Report No. 44977-UG

The Inspection Panel

Investigation Report

**Uganda: Private Power
Generation (Bujagali)
Project
(Guarantee No. B0130-UG)**

Figure 3 Levels at the Lake and Outflow (2000-2005) (Lake Victoria Basin Commission, 2006)

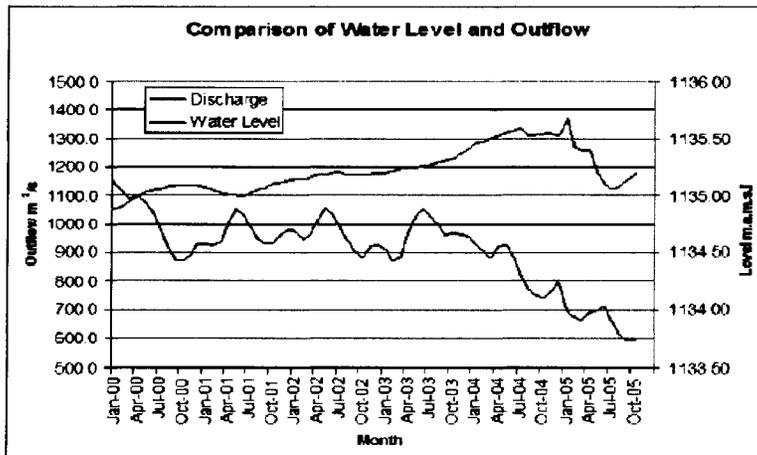
203. Figure 3 shows the lake levels and outflows for the period. It can be seen from any of the points of the curve that the outflows are above the Agreed Curve. For instance, in July 2004, when the Lake level was 1134.25 m, the flow released according to the Agreed Curve should have been 802 m³/s, while the actual outflow exceeded 1300 m³/s.

Figure 4 Comparison of Water Level and Outflow

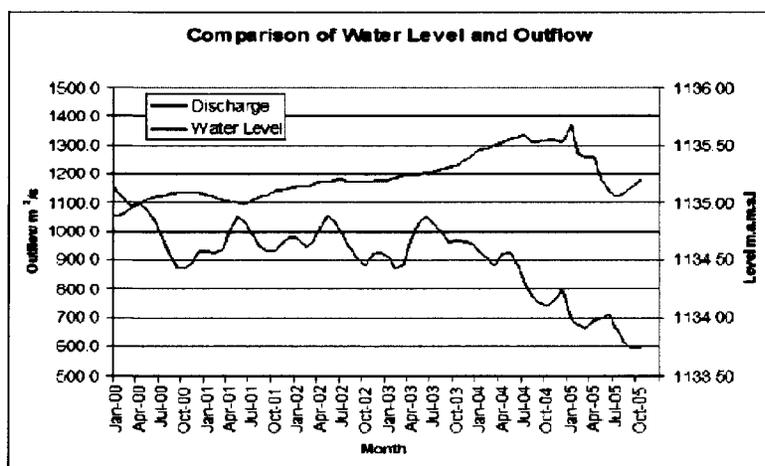
204. The PAD states that: “Since the end of 2005, the Government has steadily decreased hydropower generation in an effort to return to the Agreed Curve operating regime. Water flows for power productions are being scheduled in such a way that the return to the Agreed Curve is achieved as soon as reasonably possible.”¹⁶⁸ (emphasis added)

Figure 8 Projected Electricity Tariff Path (2000-16)

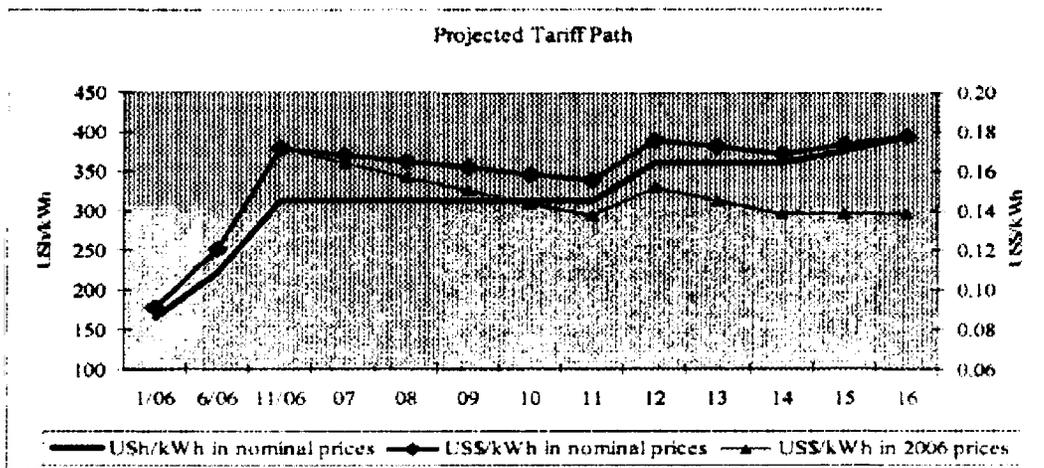
330. The PAD’s statement simply asserts that the Economic Study shows that the tariff may drop by up to 10 percent, without qualifying the statement in light of the increases in EPC and transmission costs after the Economic Study was prepared and that were recorded in the PAD (but before it was finalised). The issue of electricity tariffs and affordability is of such high importance to the people and communities. **The Panel finds that, in order to comply with the requirements of OP 10.04, the PAD should have qualified its statement about the projected drop in tariffs to take into account the impact of EPC and transmission cost increases.**³¹⁵
331. The PAD presents its own estimates of the projected levels of the weighted average retail tariff path, based on a different and presumably later Economic Study, shown in Figure 12.2 (below) :
